SOUTH WAIRARAPA DISTRICT COUNCIL

8 AUGUST 2012

AGENDA ITEM C3

MARTINBOROUGH SQUARE RESERVE – APPROVAL OF MANAGEMENT AND DEVELOPMENT PLAN

Appendix 1 – Extent of Martinborough Square Management Plan

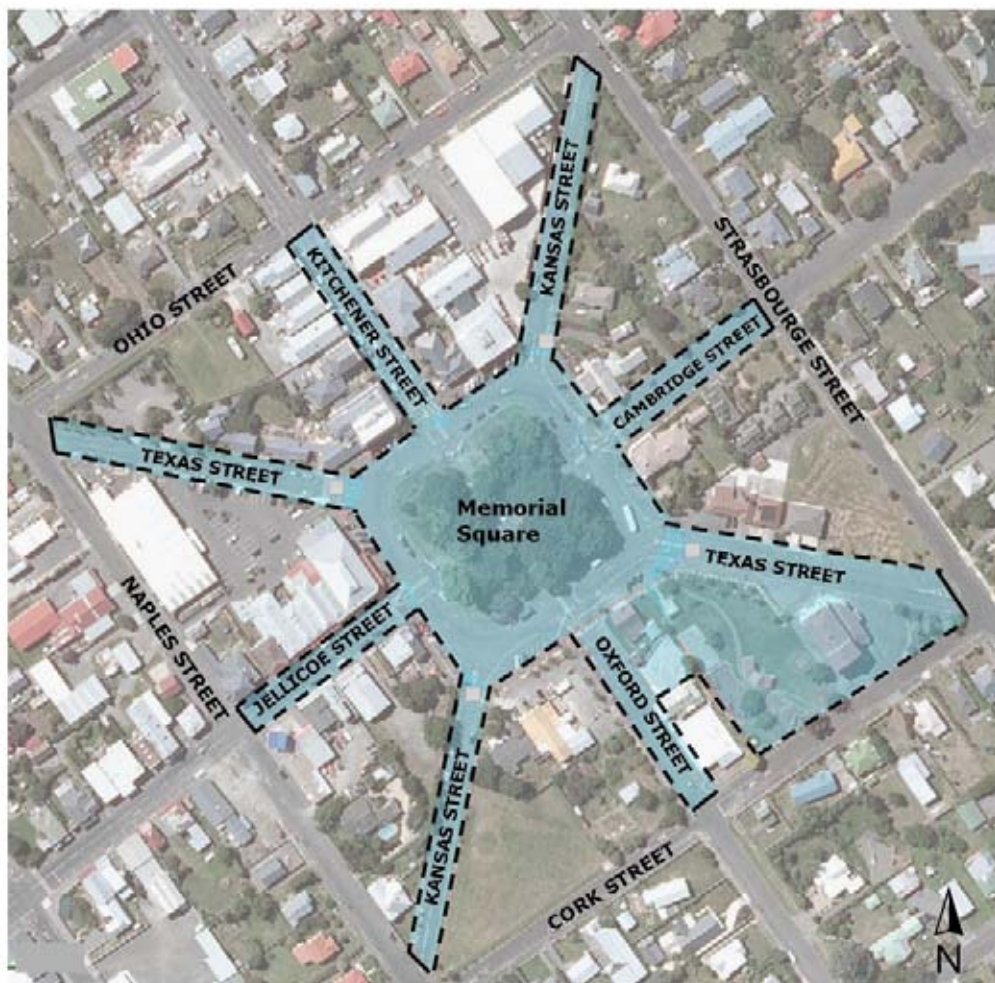
No.	Name/group	Summary 1st round submissions	Summary 2nd round submissions	Officer Comments	Recommendations
		<p>Tree maintenance has not been going fast enough and most of the trees are sorry species, and please clarify what is to be done with the grass in the square.</p> <p>Suggest more grass space with seats and picnic tables.</p>		<p>inward.</p> <p>Agree that trees in the central square need maintenance and thinning.</p> <p>No changes to the grass are proposed but the Draft Development Plan does address additional picnic tables and seating.</p>	
23	Garry Jackson	<p>Suggest no bollards around the Town Hall; do not widen the footpaths and no extra trees past the Town Hall on in the footpath.</p> <p>Don't reduce parking as people already use the fire station grounds.</p> <p>Leave the Boer Memorial concrete as it is and do not put in hedges, leave the flowers, maybe resurrect seats on the back. Pukemanu corner had hedges previously but removed them.</p> <p>Do not put trees around the promenade and complete the pedestrian crossings.</p> <p>WWII memorial should just be painted and tidied, changes would make waves.</p> <p>There are enough picnic tables and seats, people use blankets not tables.</p>		<p>Comments regarding the Town Hall and Pukemanu corner are no longer applicable to this plan.</p> <p>Confirm that trees will not be planted in the promenade, but there will be two specimen trees at each entrance.</p> <p>Confirm that the crossings are part of the Draft Development Plan.</p> <p>Hedges will not be planted around the Boer Memorial; the roses will remain.</p> <p>Council wishes to encourage use of the square, hence the addition of more seats and tables.</p> <p>Confirm that the WWII memorial will not be altered.</p> <p>Agree that the boundaries of the</p>	<p>Amend Appendix 1 (reserve map) so the boundaries are more clear.</p>

BOER WAR MEMORIAL

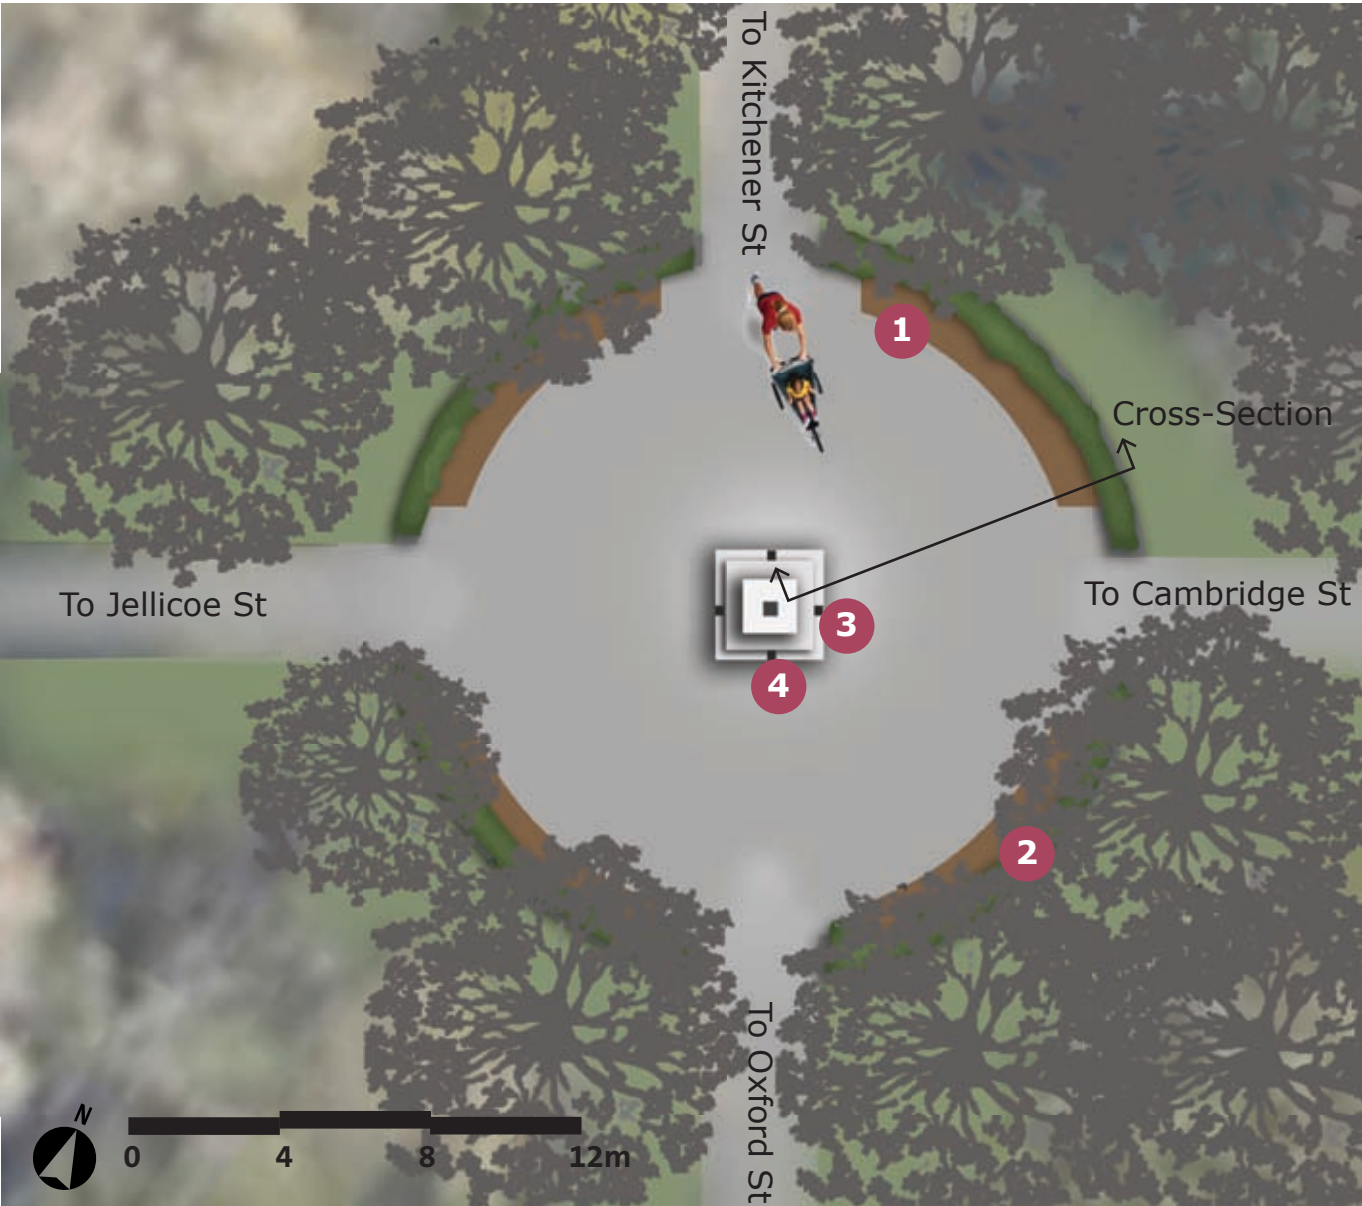
- Boer Memorial page: Delete reference to flowers and change item 2 to read "...and ensuring safety. Roses will be replaced with low perennial shrubs. The 3 remaining Peace Roses will be moved to their own dedicated garden."

- Item 4 on the Boer Memorial page: Change to read "...focus at night, where colour filters will be used only on special occasions."
- Promenade page: Change to show no widening of the promenade area, but that the promenade will be upgraded with existing paving (asphalt and brick).

PROMENADE

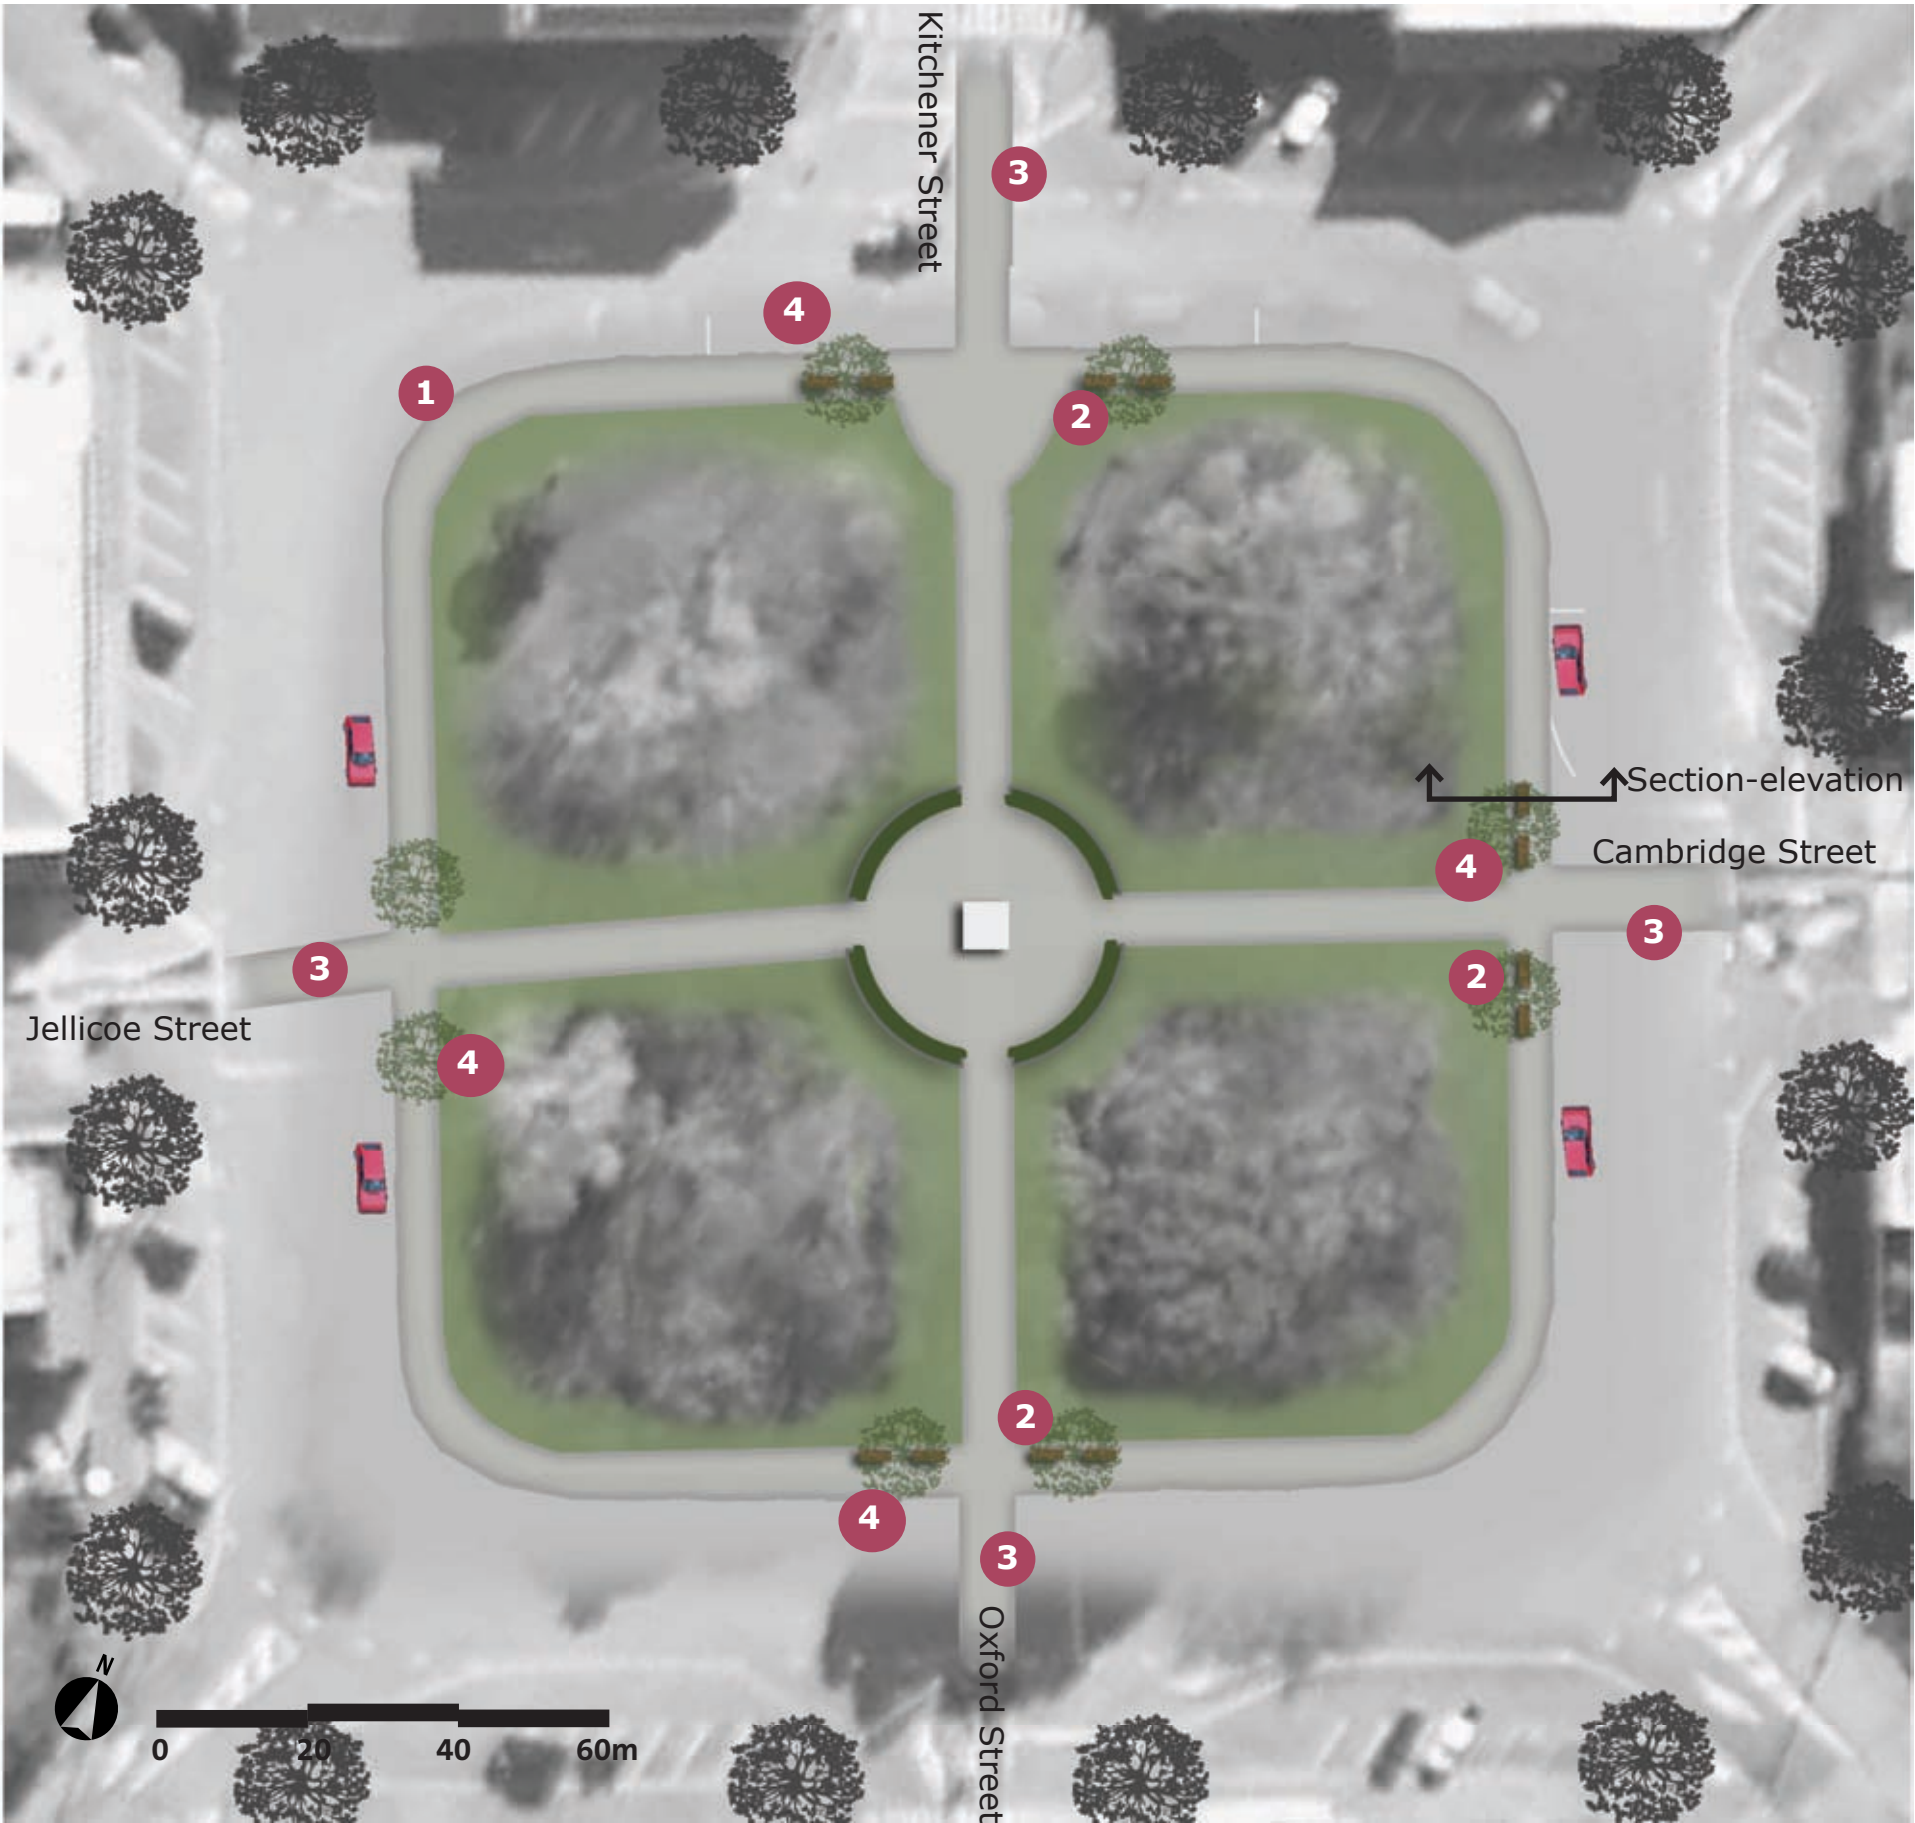
- Item 3 on the Promenade page: Change to read "...draw people into the square. Annuals will be planted at each pedestrian crossing."
- Add item 5 to the Promenade page: "Plant one native tree in each quadrant of Soldiers Memorial Park, with a plaque for each to commemorate the four original Martinborough settlers."
